## **MEMORANDUM**

**Subject:** **DESIGN RESPONSE CONFERENCE #10**  
**TOUCHSTONE (PARKPLACE)**  
**FILE DRC09-00002**

# **Building A Proposed Final Design**

## **Building A - Outstanding items from last meeting (10/19/09):**

**DRB Comments from 10/19 Meeting  
Item 2: Northwest Corner Articulation**

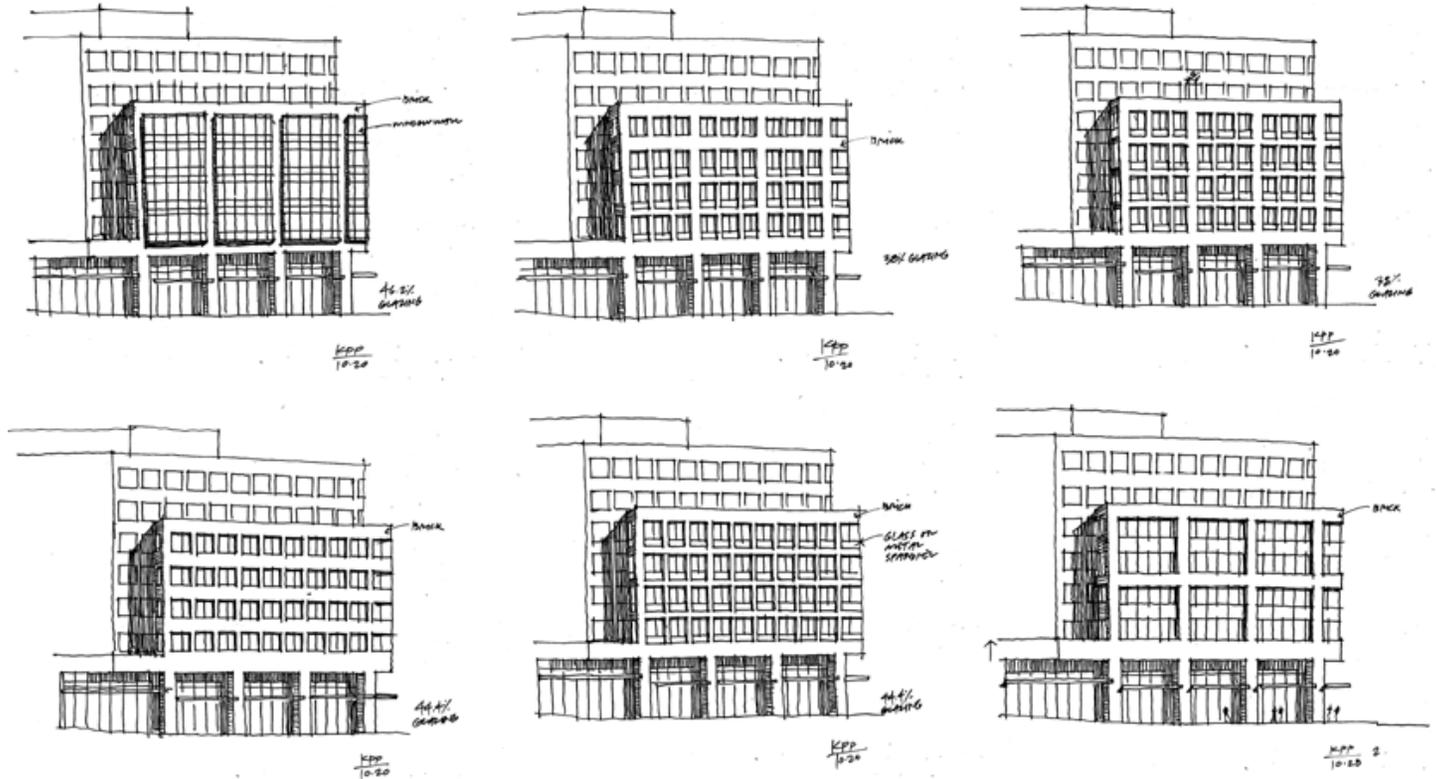
DRB comment:

Study glazing pattern and materiality of north-west building corner. There is an opportunity for this element to be further distinguished from the NE corner, and to be more expressive of its solidity and connection to the ground.

Response:

We studied a number of options that reduced the amount of glass and increased the masonry material.

Resolution:

The preferred option strikes a balance between glassiness and solidity and relates to the pattern utilized on Buildings B & C. It also gives this element a more substantial visual weight.

The contrast between the lightness of the northeast corner and the solidity of the northwest corner further reinforces the diagrammatic clarity of the design.

**DRB Comments from 10/19 Meeting  
Item 4: South Elevation Articulation**

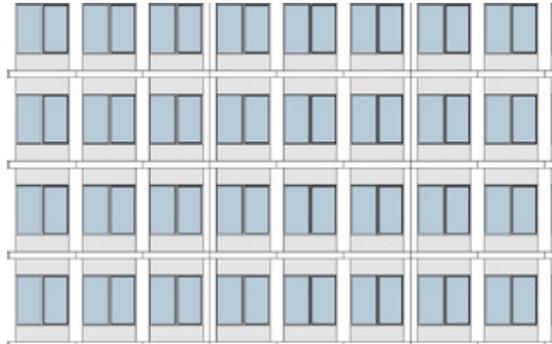
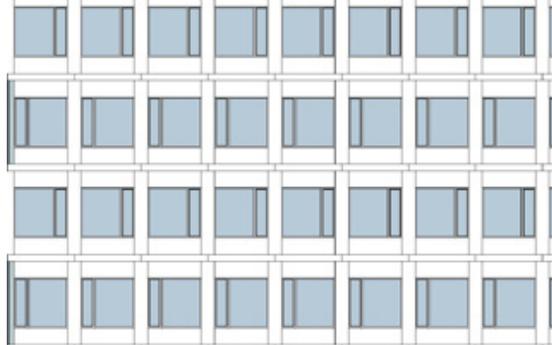
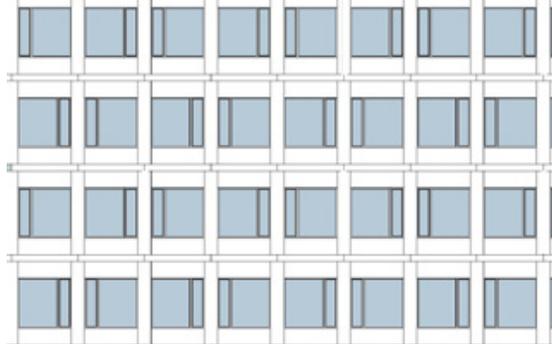
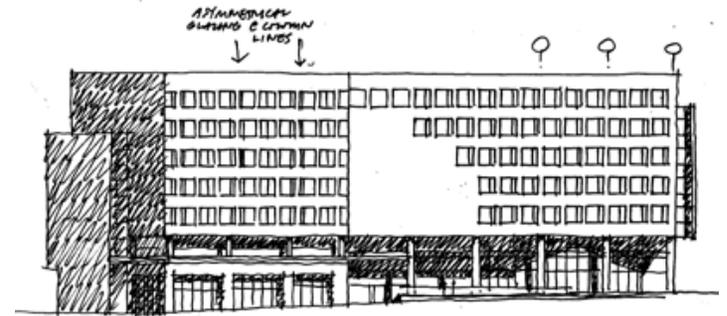
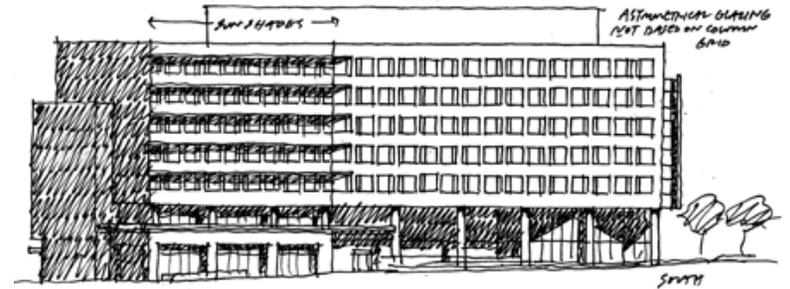
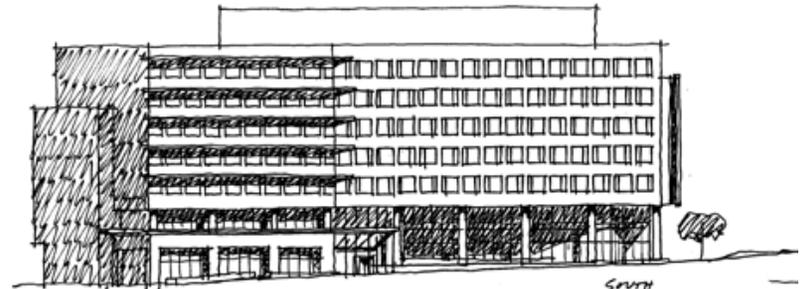
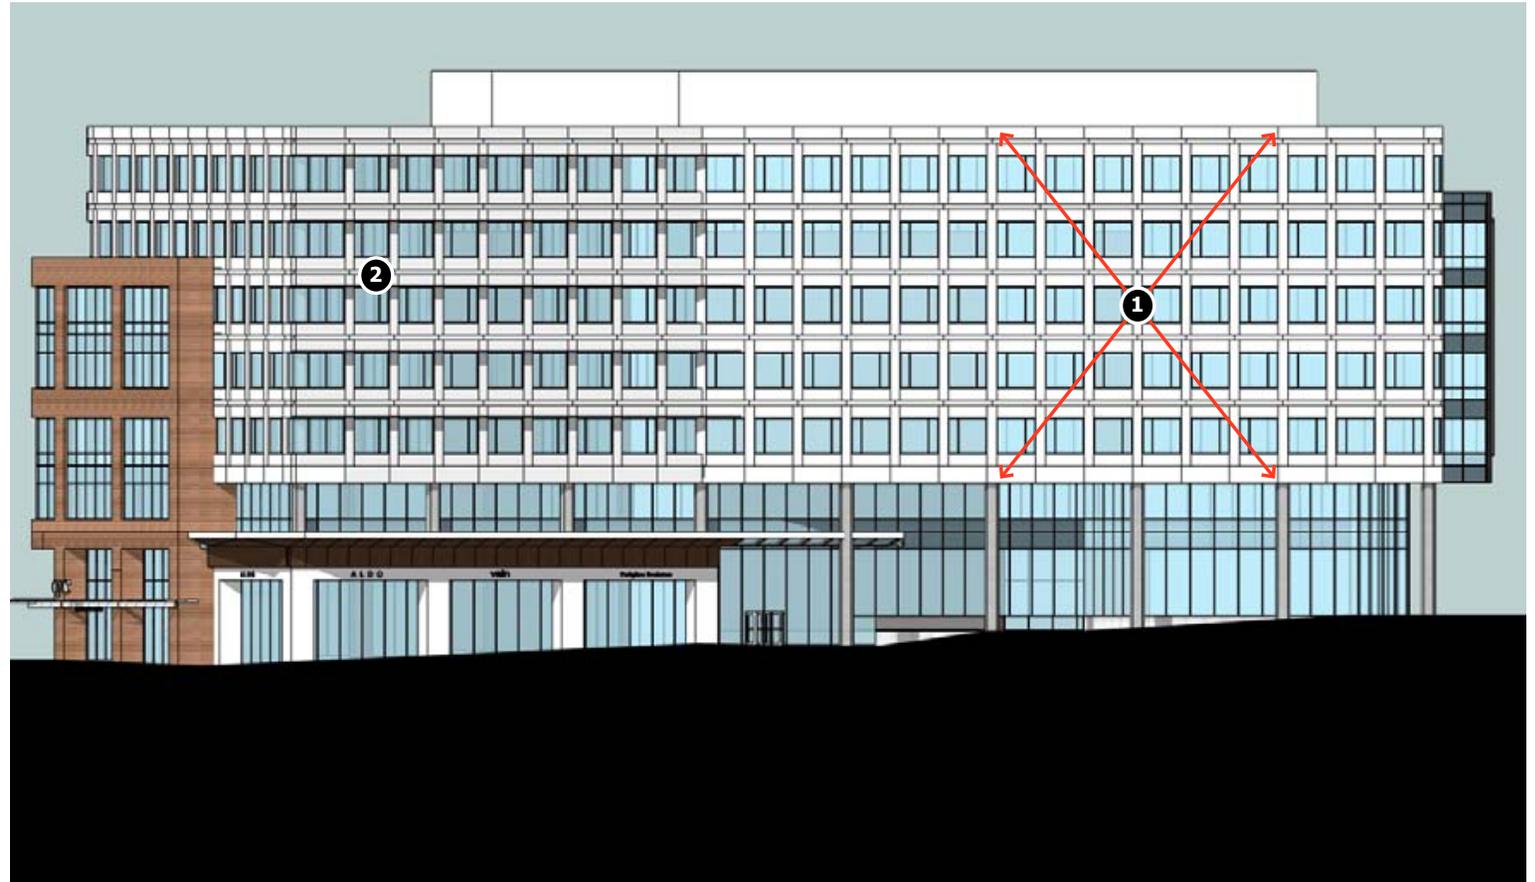
DRB comment:

Study south elevation to increase visual interest.

**Response:**

This facade system is intended to be relatively understated to form the background for more sculptural elements of the building, so we did not investigate major massing changes on this elevation.

We studied glazing patterns to create additional visual interest. Given the oblique viewing angle of these facades, we felt that a subtle variation would create the right amount of articulation.

Resolution:

The preferred option uses an asymmetrical window division to create a diagonal movement in the facades. ❶ In addition, the sunshades on the west portion of the elevation help distinguish this facade. ❷

When seen as a whole, the south elevation of Building A is animated by numerous elements. The pedestrian's view is dominated by the bold sculptural moves in the first two floors, while the upper floors employ more subtle techniques to create movement and variety.

**DRB Comments from 10/19 Meeting  
Item 5: Roof Edge Articulation**

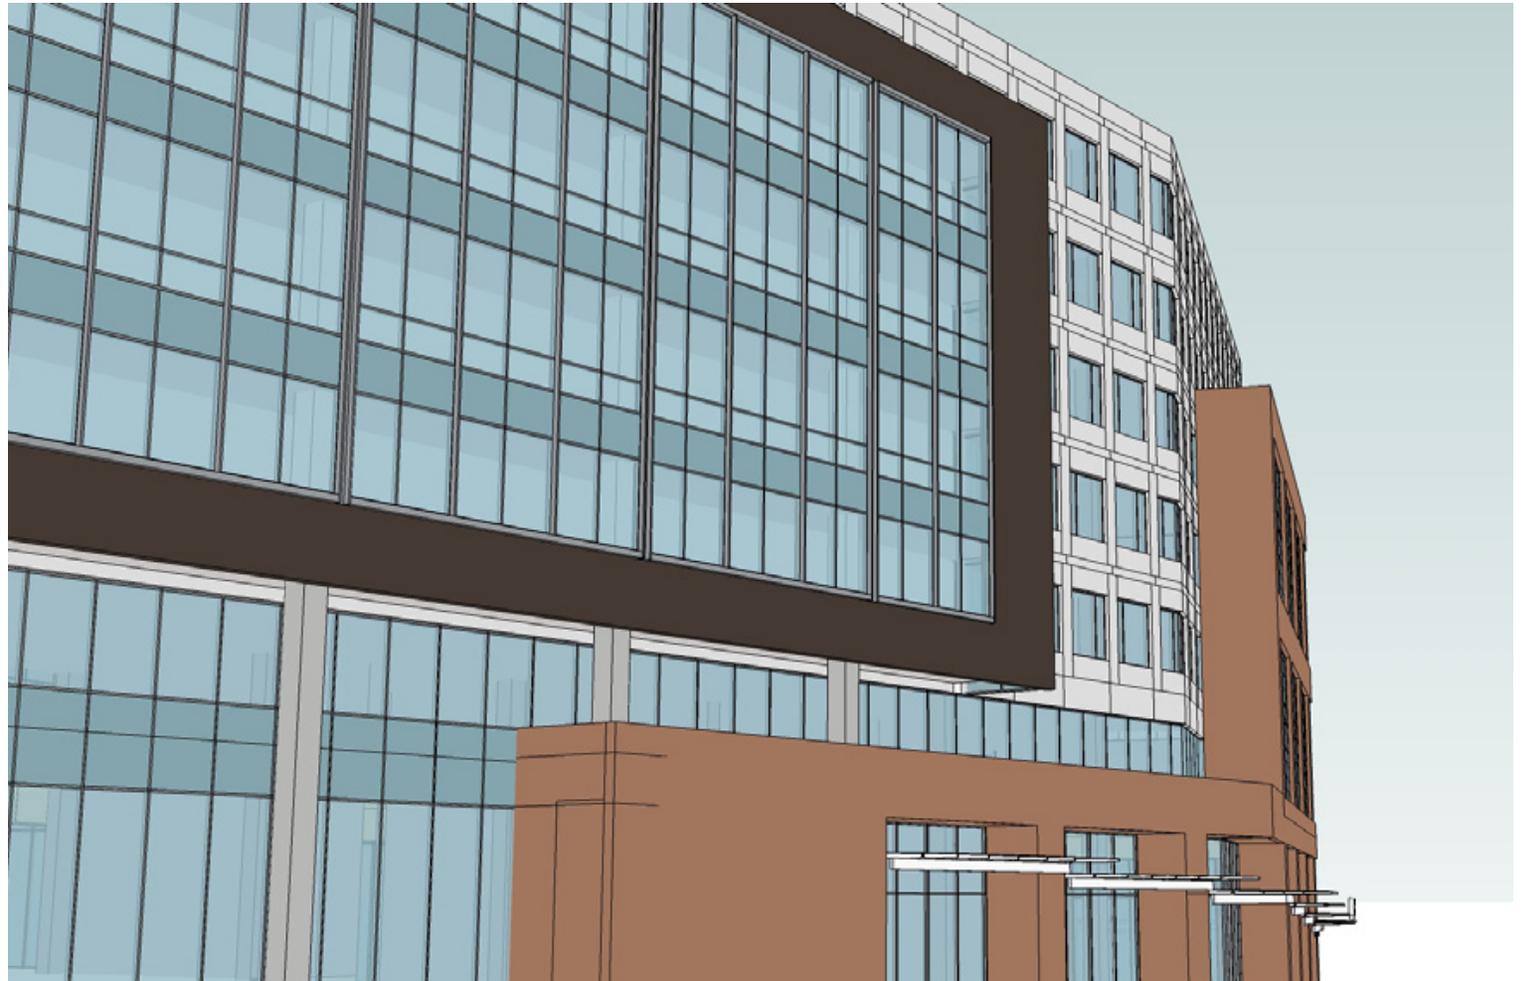
DRB comment:

Study roof edge detail to add visual interest.

Response:

We studied several options for adding detail to the roof edge. The idea of varying the parapet height, or crenellating the edge, resulted in an over-complicated design. Creating a cornice would be inconsistent with the contemporary architectural language of the building, and accentuating the edge with a band of some kind felt contrived.

In the end, we felt that the massing and articulation of the design are successful, and provide enough variation in materials, surfaces and volumes without the addition of superfluous detail at the roof edge.

Consistent with the Design Guidelines, the top floor(s) of the building, by stepping back and changing material from the lower floors, give the building a "distinct profile against the sky."
